NorthConnex Project (SSI 6136) CoA E11 Modification Request

Amendment of VOC ventilation outlet limit
Submissions report

Roads and Maritime Services | November 2019

Figure 2-5 Design analysis A (PCU) relative to traffic design capacity

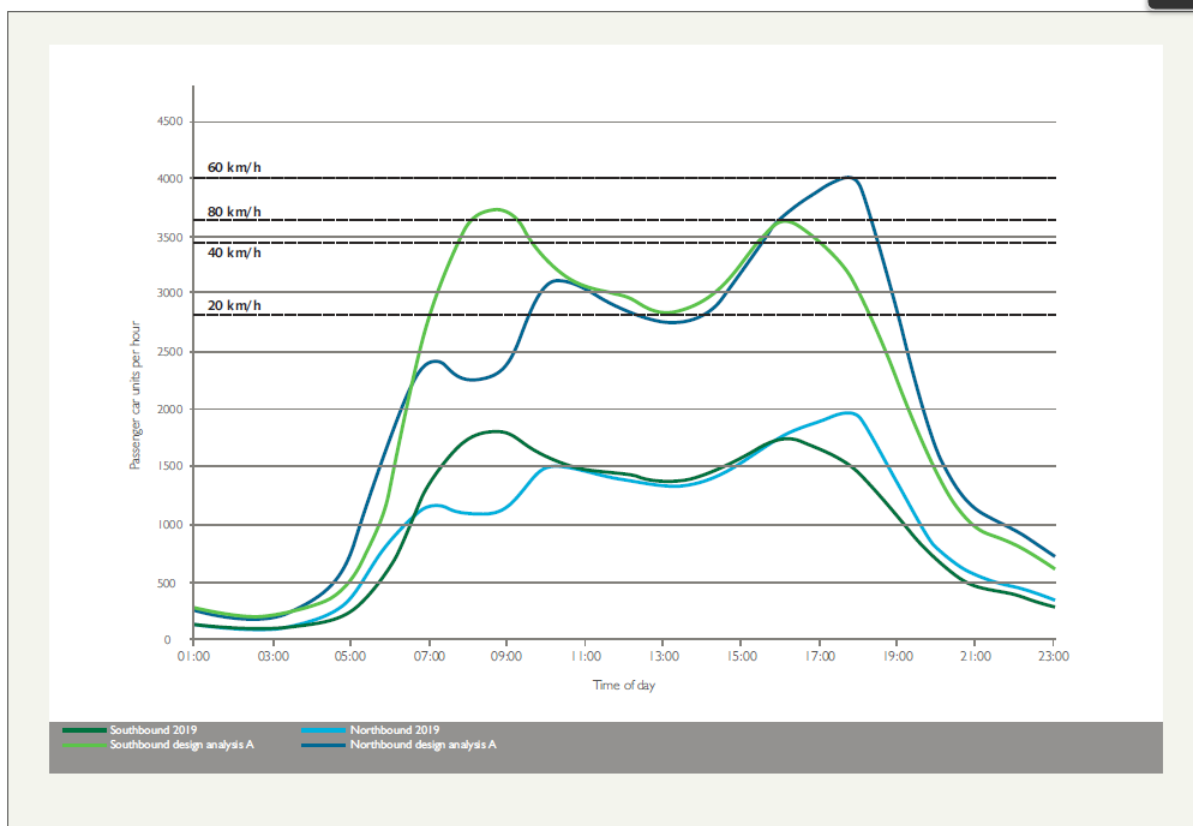
- An objection to the four-fold increase in toxic VOC levels to 4mg/m³
- 2mg/m³ VOC limit could be a reasonable compromise
- Restrict the number of incidents to avoid higher level of VOC being emitted continuously. If the new limit is for occasional use, then there should be a restriction on the number of times that VOC emissions are allowed to exceed 1mg/m³ before triggering condition E13.

The VOC values presented in Table 7-101 of the EIS are based on free-flowing, expected traffic volumes. These traffic volumes are significantly lower than the physical capacity of the tunnel. As illustrated in Figure 2-5 of the SPIR, forecast traffic volumes are approximately 50% or less than the physical capacity of the tunnels.

The analysis focused on CO, NO₂ and visibility as these were the design criteria for the project. The maximum CO concentration predicted is 15 mg/m³. VOC emissions are calculated as approximately 10% of CO emissions, so this equates to a maximum VOC concentration on the outlet of approximately 1.5 mg/m³.

This is the maximum concentration of VOCs if the tunnel is at maximum physical capacity, but does not account for incidents that can result in a short-term increase in VOC emissions that the ventilation system would need to manage.

A compliance limit for VOCs in the outlet should be based on a combination of the physical capacity of the tunnels (ie maximum traffic), and ability to manage short-term incidents.

It is difficult to quantify potential short-term incidents. However, based on operational experience of the Cross City Tunnel and Lane Cove Tunnel, it is considered that a VOC limit of 4 mg/m³ provides a reasonable margin for compliance so that the ventilation system can manage the combination of capacity traffic and short-term incidents in compliance with outlet limits. A VOC limit of less than 4 mg/m³ (e.g. 2 mg/m³) is therefore not a reasonable margin for compliance.

Figure 7-20 PM10 2019 24 hour average concentrations - northern ventilation facility

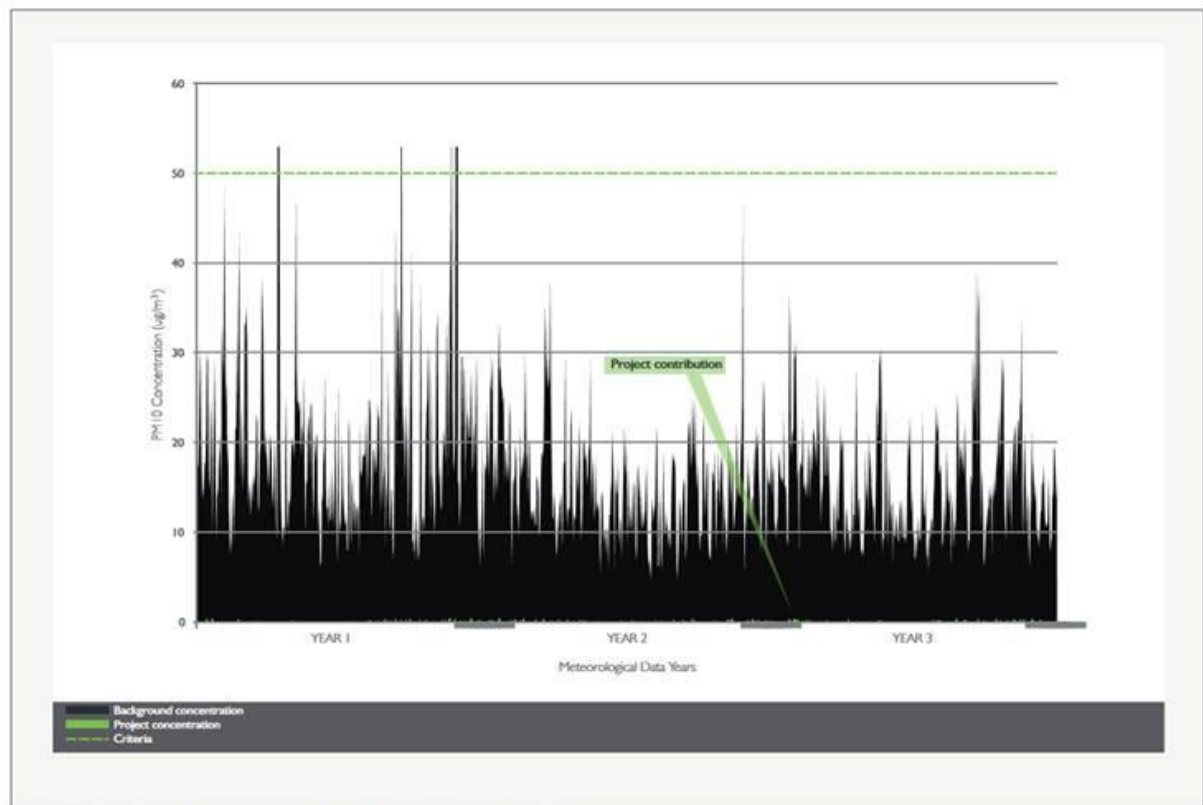
- NorthConnex will emit 500 micrograms per cubic metre of diesel particulates. The normal level across Sydney is between 8 and 25 micrograms.
- Limit the type of vehicles allowed through the tunnel, ie: no diesel fuelled vehicles/trucks.
- Exposure to diesel exhaust "can cause both short-term (acute) and long term (chronic) health effects. Diesel Engine Exhaust (DEE) is linked to both lung and bladder cancer. DEE contains a mixture of gases and soot, which is also called particulate matter.
- Request a review of the performance of smoky vehicle regulation / enforcement and whether additional or amended measures may be required.

The proposed modification will not impact day-to-day operation of the tunnel, and has no bearing on the levels of diesel particulates. It should be noted that levels of particulate in the outlet will typically dilute many hundreds of times before mixing down to ground level where people can breathe them. Levels of particulate were thoroughly assessed in the EIS and it was demonstrated that emissions from the ventilation outlets would result in little, if any, change in air quality. For example, Figure 7-20 from the EIS (reproduced below) shows outlet contribution as the green at the bottom of the figure.
